PORTLAND AVENUE REVITALIZATION

PORTLAND AVE
REVITALIZATION
PC 14105

6/16/15
STD
comments

PRE-PSE
SUBMISSION
6/8/2015

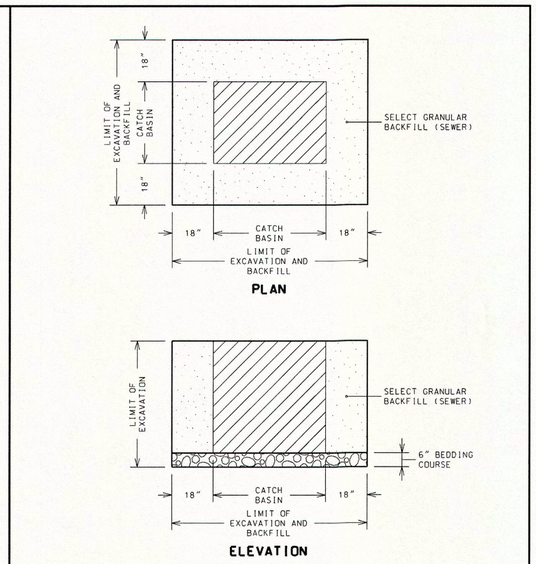
Use MCPW Detail! Figure 3.05? "New Lateral Wye Connection to Existing Non-PVC Sewer"

PARTIAL PLAN 5 - DRAINAGE IMPROVEMENTS
PORTLAND AVENUE AND TURPIN STREET
SCALE: 1" = 10'

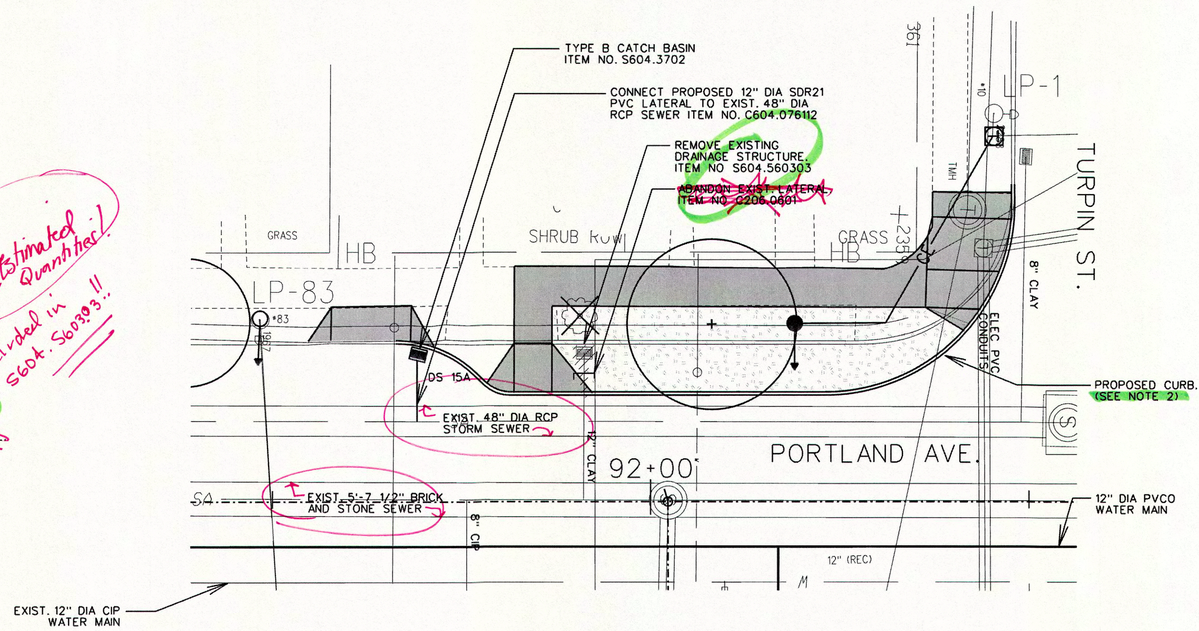
1. REFER TO DRAINAGE TABLE ON DWG CT-5 FOR ADDITIONAL REQUIREMENTS FOR DRAINAGE IMPROVEMENTS
2. REFER TO DWGS. CD-14 TO CD-18 FOR STREET IMPROVEMENT DETAILS.
3. (?) see partial plan 1 CD-12

GATEWAY FEATURE WALL - PORTLAND/NORTON INTERSECTION
NOT TO SCALE

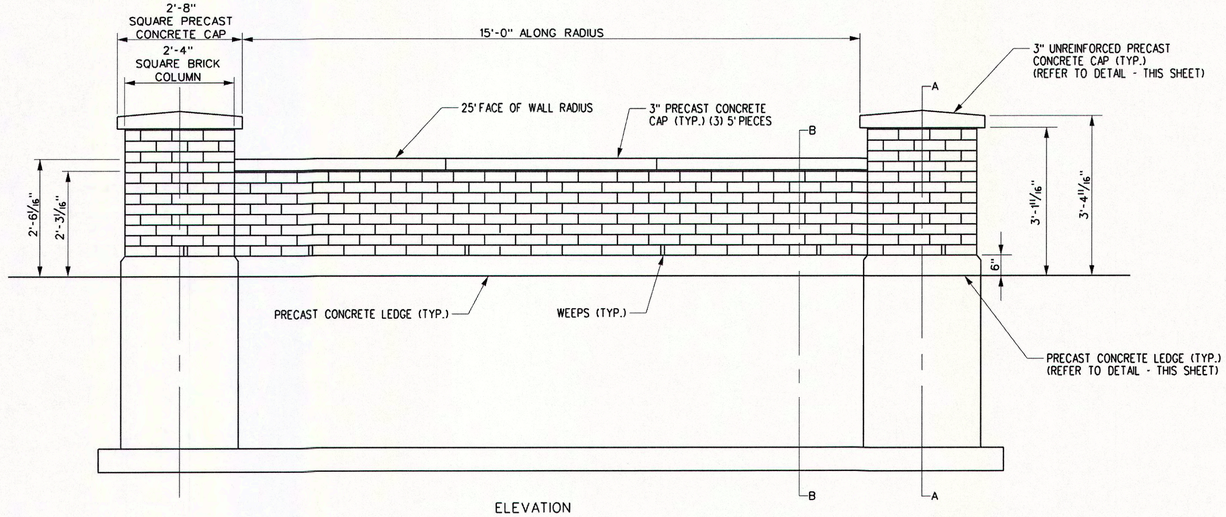
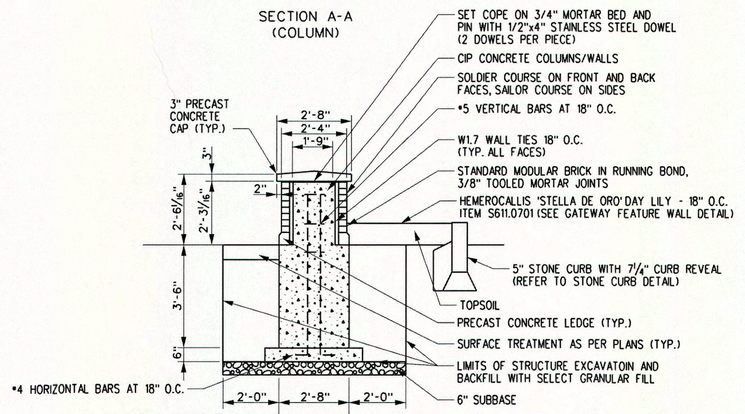
THIS COULD BE A PROBLEM - CITY REQUIRES (REQUIRES) MIN OF 6' OF CLEARANCE BETWEEN OPPOSING FACES OF VERT ELEMENTS FOR SNOW PLOW OPERATIONS - BOLLARDS, WALL, LANDSCAPE CURB ARE ISSUES IN THAT SENSE

GATEWAY FEATURE WALL
CHAPIN STREET LOCATION DIAGRAM
NOT TO SCALE → SHOW TO SCALE

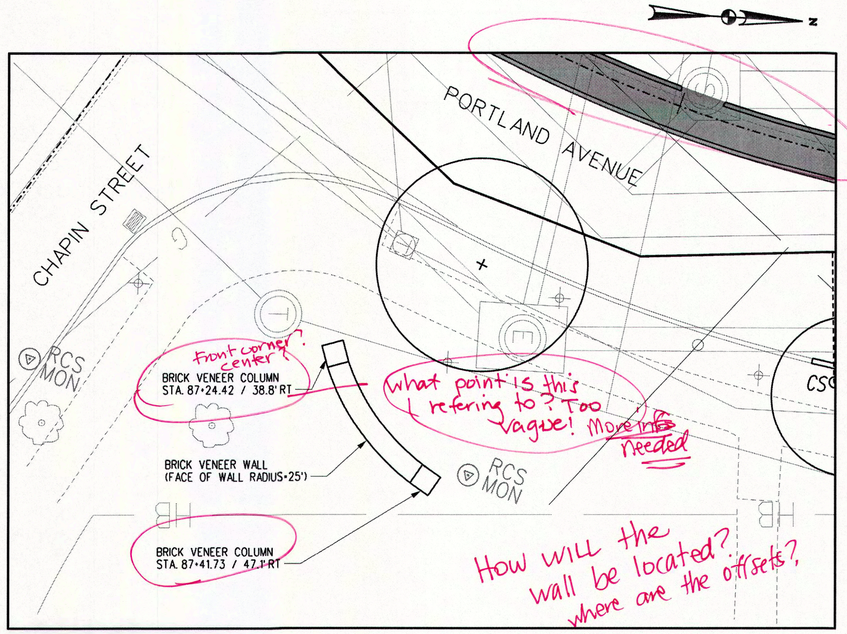
If referencing stationing & offset show STATIONS! ALSO SHOW TO SCALE!
